September 13, 2018
PG4461-LET.01

Subject: **Floodproofing Design Report**
Proposed Multi-Storey Residential Building
263 Greensway Avenue - Ottawa

<p>154 Colonnade Road South Ottawa, Ontario K2E 7J5 Tel: (613) 226-7381 Fax: (613) 226-6344 www.patersongroup.ca</p>	MANOR PARK MANAGEMENT 263 GREENSWAY AVENUE OTTAWA, ONTARIO		Date:	Report No.:
			08/2018	PG4461
			N.T.S.	Drawing No.:
	FLOOD PROOFING DETAIL		Drawn by:	Checked by:
		MPG	CB

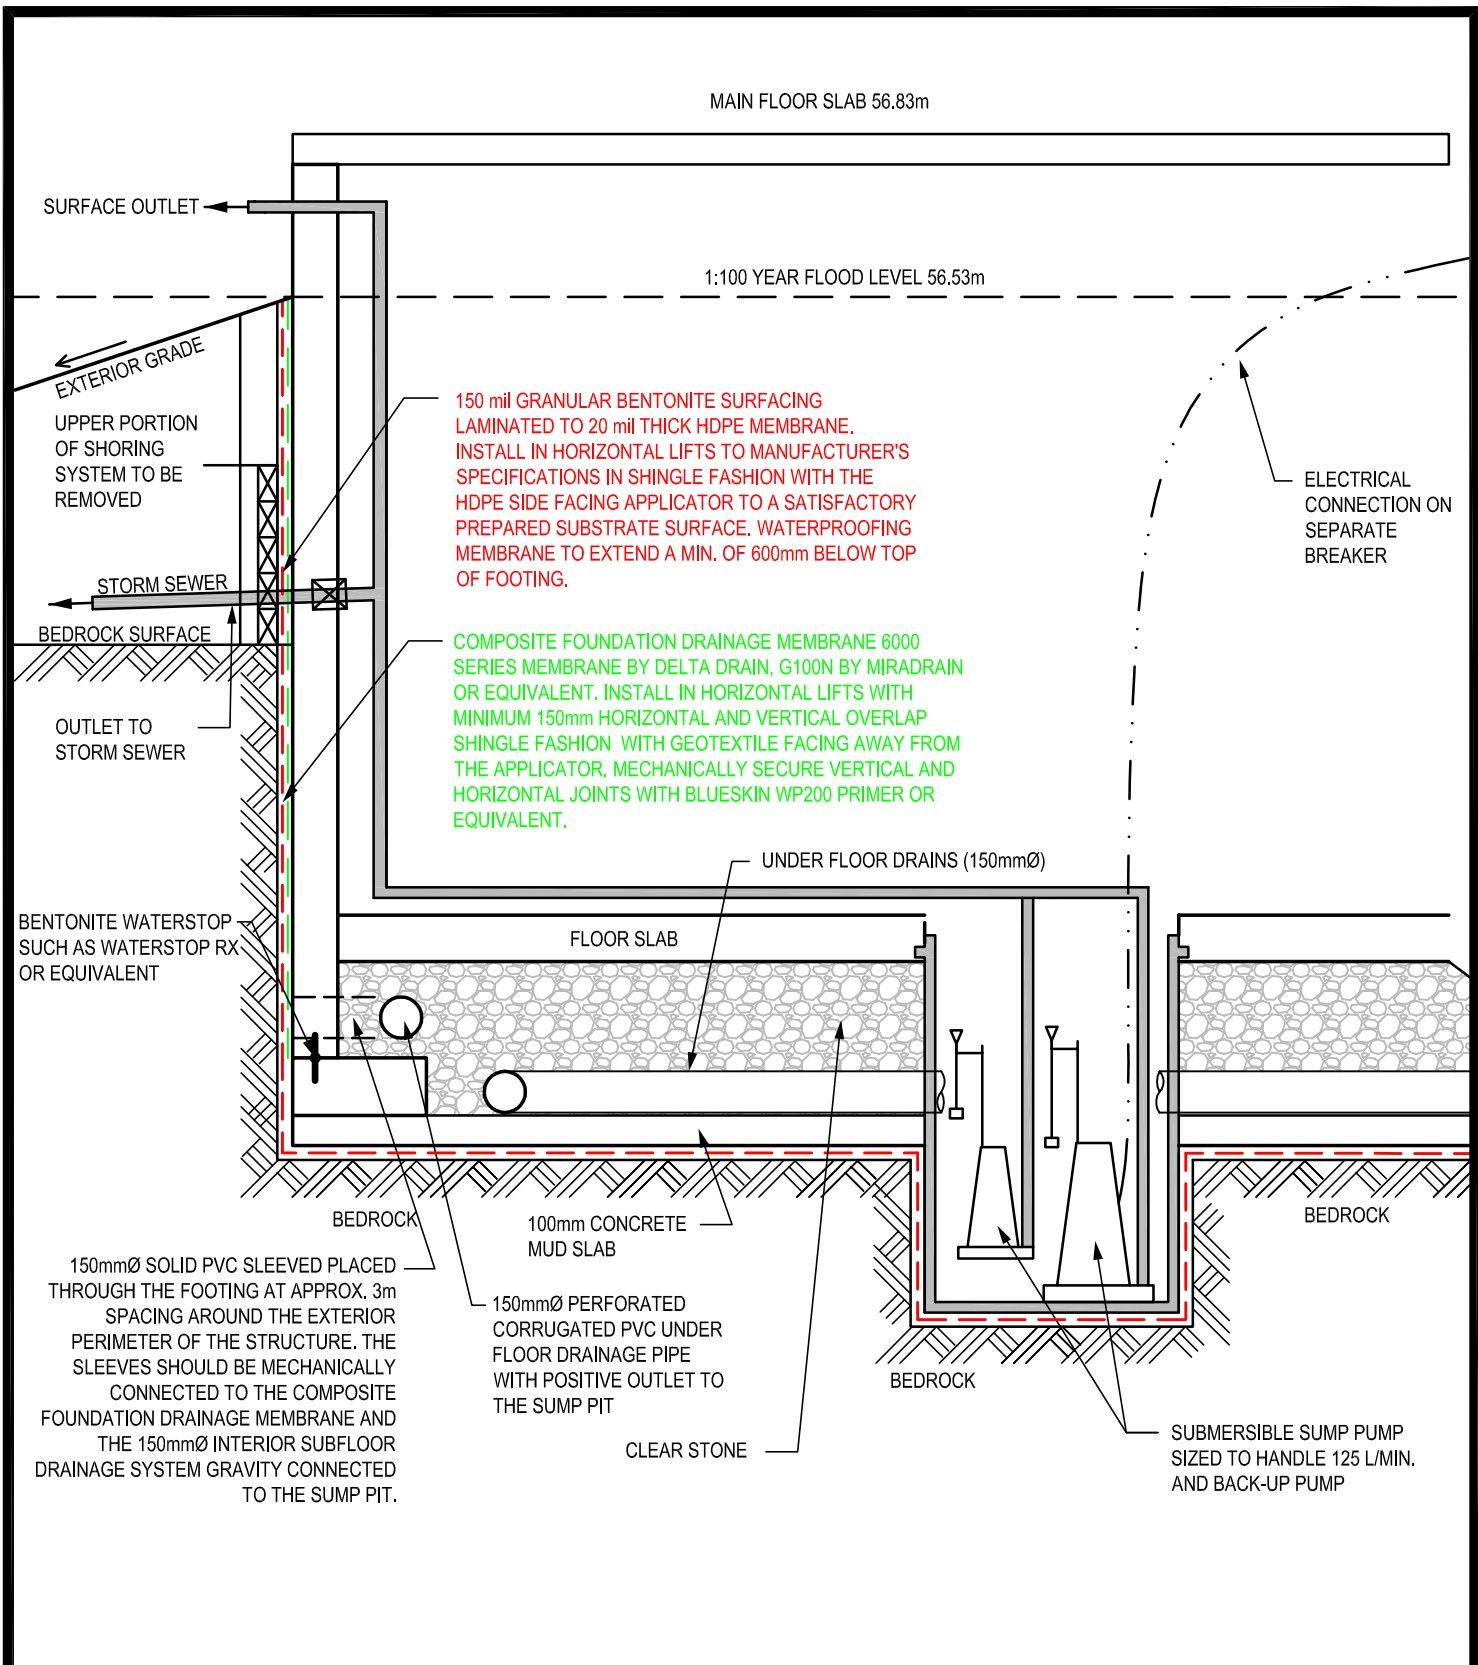
- ❑ “Structural details of foundation elements and specifications for fill materials and compaction procedures must be prepared or approved by a qualified Professional Engineer.” Structural details to be provided by the structural engineer for Paterson to include in the Floodproofing Design Report.

- ❑ “The responsible Professional Engineer shall certify in writing that the design has taken into account regulatory flood (velocity and depth of flow) and site (soil type, bearing capacity etc.) conditions encountered at the specific location of the development”

- ❑ “The Professional Engineer’s certificate must confirm that the foundation and building are designed to withstand hydrostatic pressures and / or impact loading that would develop under water level equivalent to the design storm [1:100 year flood level plus (minimum) 0.3 metres of freeboard]”

- ❑ “The responsible Professional Engineer must also identify all operation and maintenance requirements to be met in order to ensure the effective performance of the floodproofing measures over the design life of the structure.”

Refer to Figure 1 - Floodproofing Detail attached to the present report for additional information.

It is expected that insufficient room will be available for exterior backfill below the bedrock surface and/or where a temporary shoring system is installed. It is suggested that the foundation drainage system for blind side foundation wall pours can be as follows:

- Face of temporary shoring system or adequately prepared bedrock vertical surface (Grind the bedrock irregularities to create a smoother bedrock vertical surface).

- Waterproofing membrane securely fastened against the satisfactorily prepared bedrock surface or temporary shoring system. The waterproofing membrane can consist of a 150 mil bentonite surfacing laminated to a 20mil thick HDPE membrane. Install in horizontal lifts to manufacturers specifications in shingle fashion with the geotextile surface facing the bedrock and shoring system.

- A composite foundation drainage board (such as Miradrain G100N, Delta Drain 6000 or equivalent) should be securely fastened to the prepared vertical bedrock face and shoring surface over the waterproofing membrane with the geotextile side facing the bentonite waterproofing. The concrete foundation wall will then be poured against the composite foundation drainage board.

- A bentonite or PVC waterstop product, such as Waterstop RX, should be installed at the cold-joint between the footing and the foundation wall.
- It is recommended that the waterproofing membrane and composite drainage board extend down to the footing level. It is recommended that 150 mm diameter sleeves at 3 m centres be cast at the foundation wall/footing interface to allow the infiltration of water to flow to the interior perimeter drainage pipe. The perimeter drainage pipe and underfloor drainage system should direct water to the sump pit(s) within the lower basement area.
